CITY PLAN COMMISSION**THURSDAY, OCTOBER 24, 2024****FILE NUMBER:** S234-210**SENIOR PLANNER:** Hema Sharma**LOCATION:** Storey Lane at Harry Hines Boulevard, southeast corner**DATE FILED:** September 26, 2024**ZONING:** IR**CITY COUNCIL DISTRICT:** 6**SIZE OF REQUEST:** 0.699-acres**APPLICANT/OWNER:** Ector Convenience Store, Inc.

REQUEST: An application to create one 0.699-acre lot from a portion of tract of land in City Block 5794 on property located on Storey Lane at Harry Hines Boulevard, southeast corner.

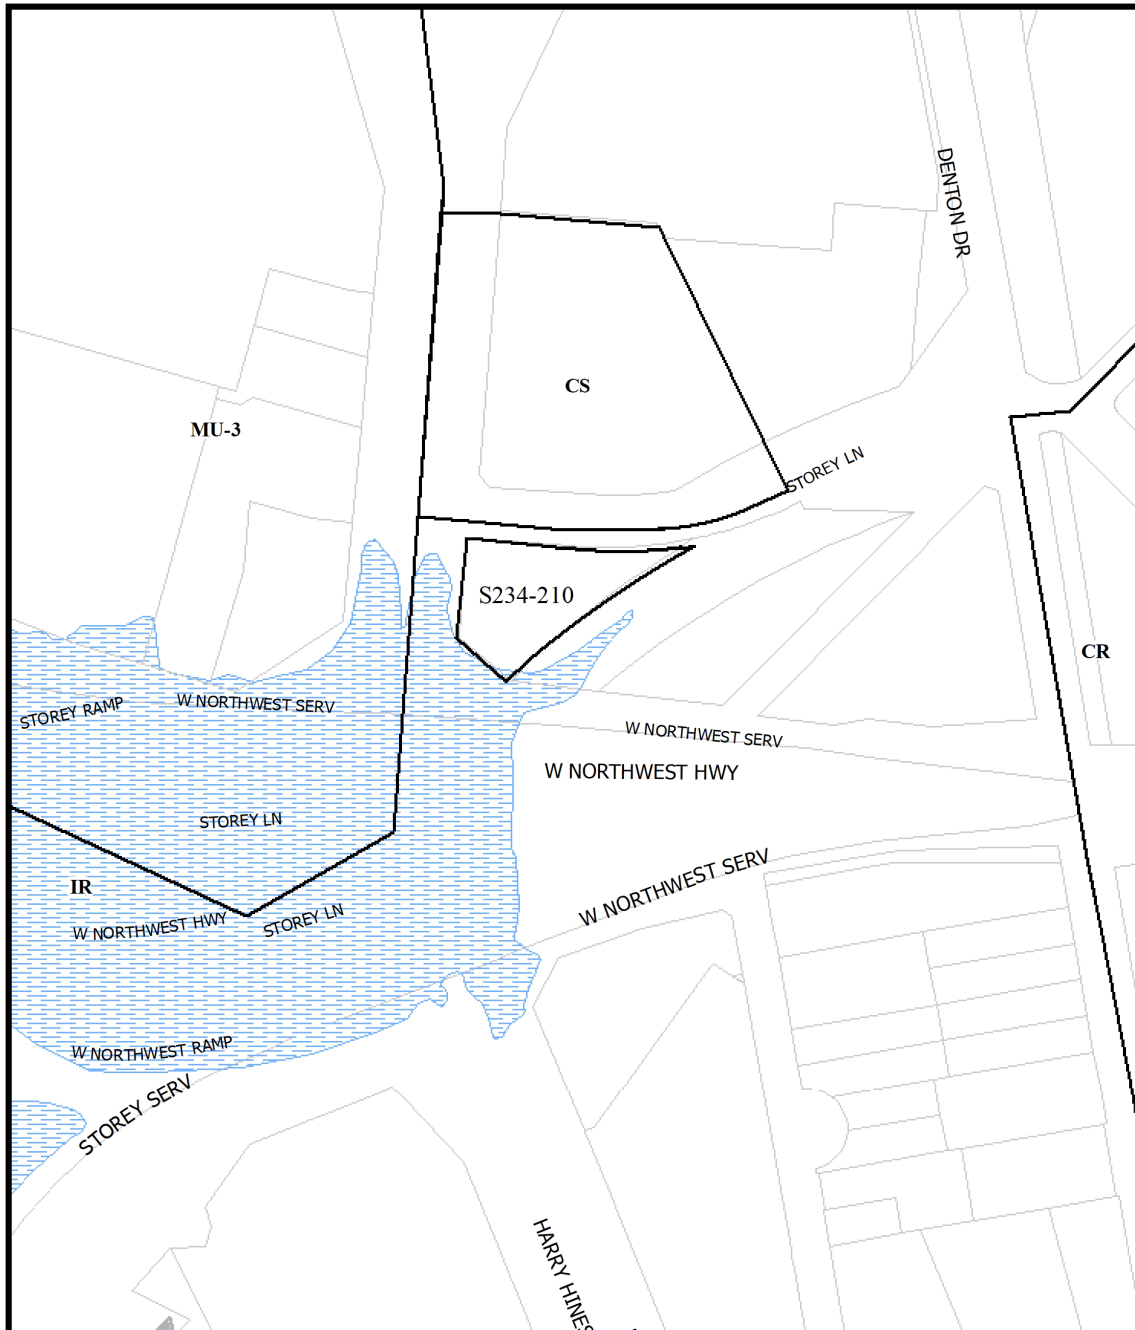
27. Prior to final plat, submit a completed final plat checklist and all supporting documents.
28. On the final plat, show the correct recording information for the subject property.
29. On the final plat, show how all adjoining right-of-way was created. Section 51A-8.403(a)(1)(A)(xxii).
30. On the final plat, show distances/width across all adjoining right-of-way
